27 April 2005

Subject: Final Site 32 Cluster Removal Action Work Plan (RAW), Installation Restoration
Program Site 32 Cluster (32C), Vandenberg Air Force Base (AFB), CA

A	SITES 32 AND 35 ADMINISTRATIVE RECORD LIST
B	APPLICABLE RELEVANT AND APPROPRIATE REQUIREMENTS
C	HEALTH AND SAFETY PLAN ADDENDUM
D	REMOVAL ACTION ALTERNATIVE COSTING SUPPORT
E	RESPONSE TO STATE REGULATORY COMMENTS

Figure 4.2-1

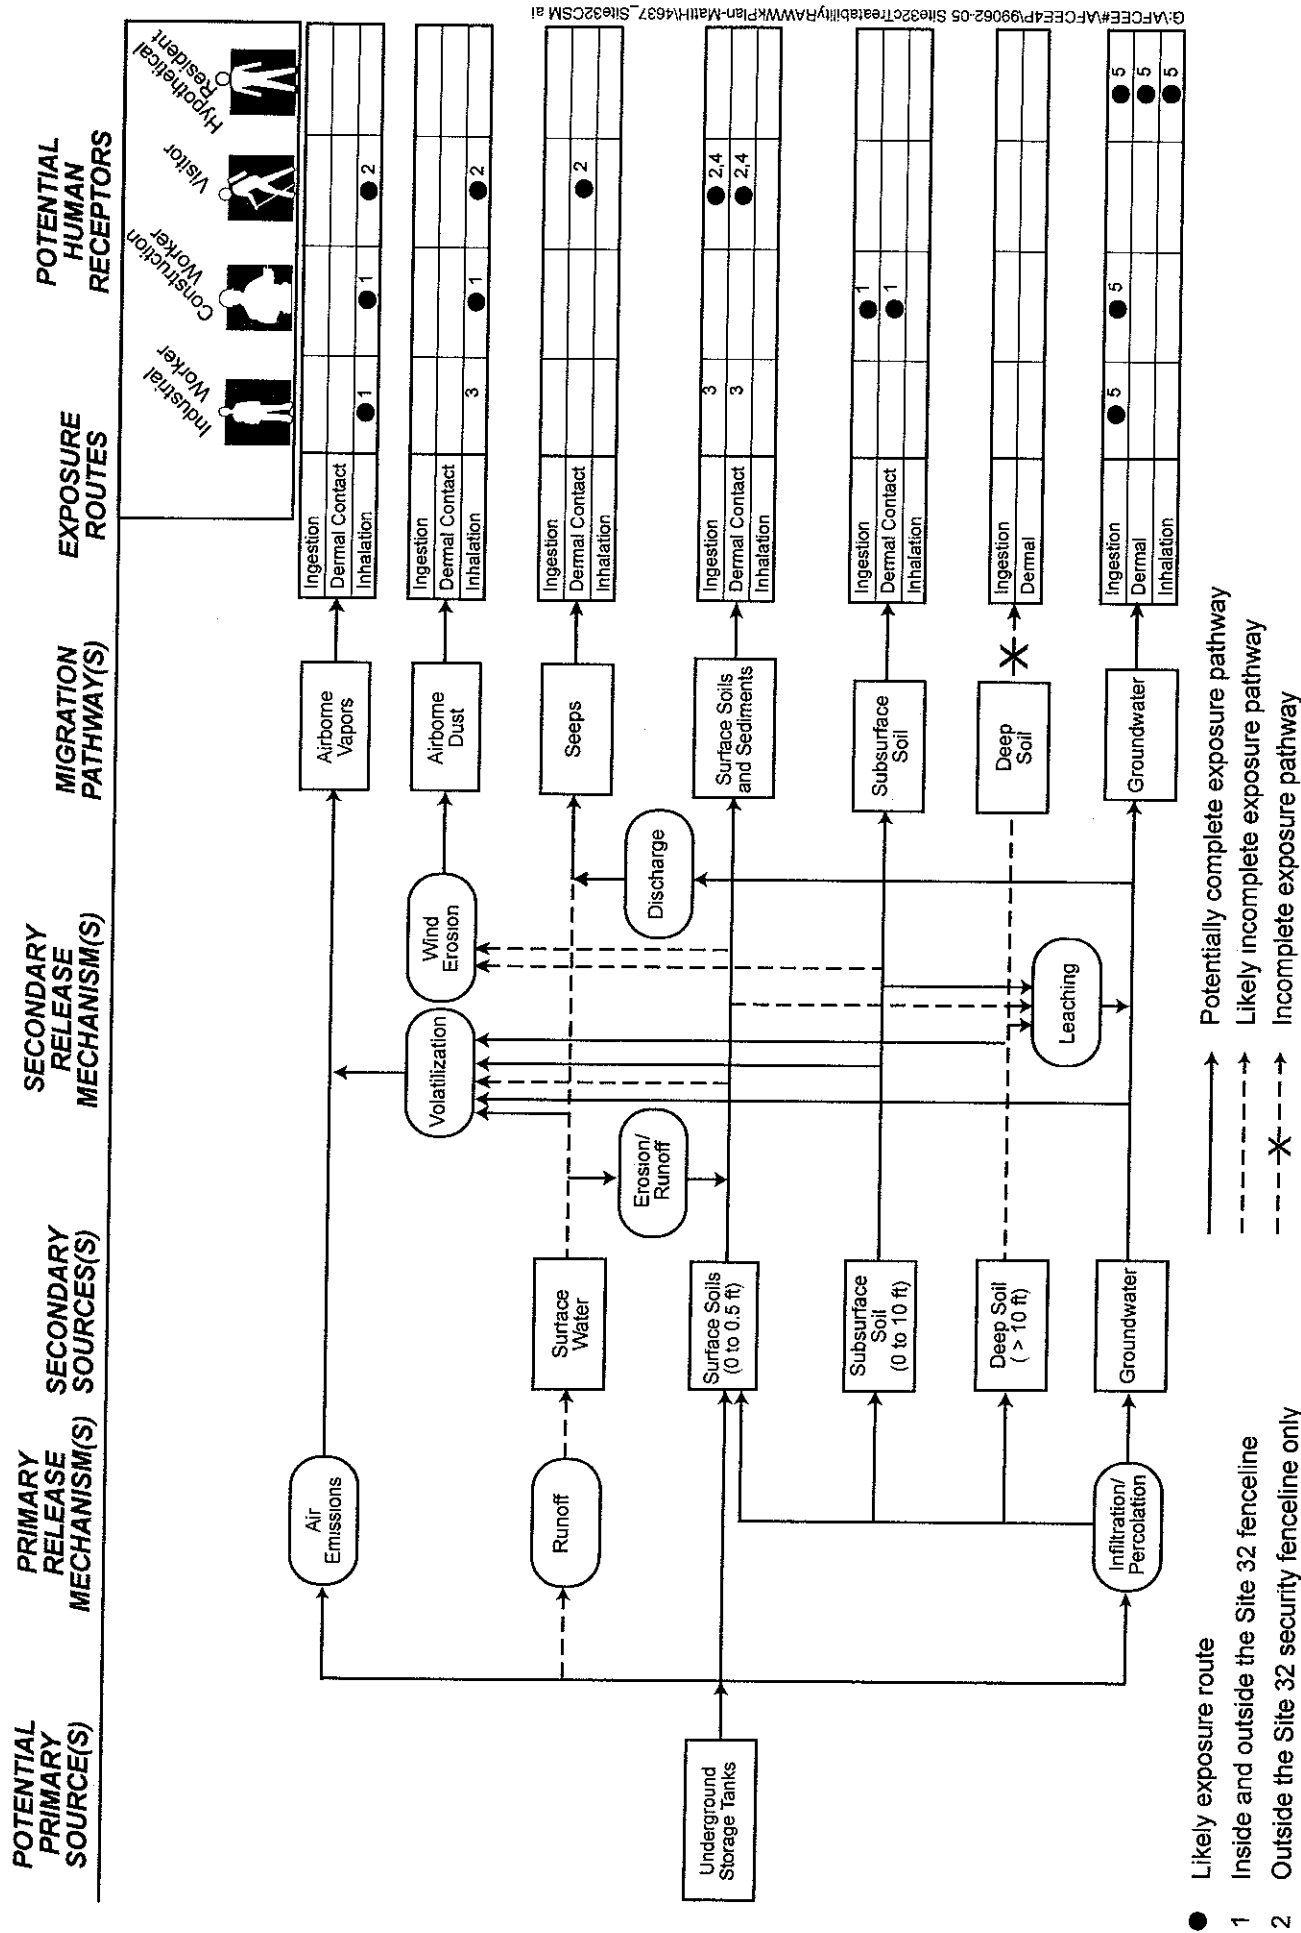
Section 4.1 Conceptual Site Model: VOCs in soil and groundwater are not shown on Conceptual Site Model (CSM) Figure 4.1-1. Also, please provide a figure showing the CSM for current and future human and ecological receptors exposure pathways. In addition, please provide the cumulative risk from soil and groundwater at the Site 32 cluster.
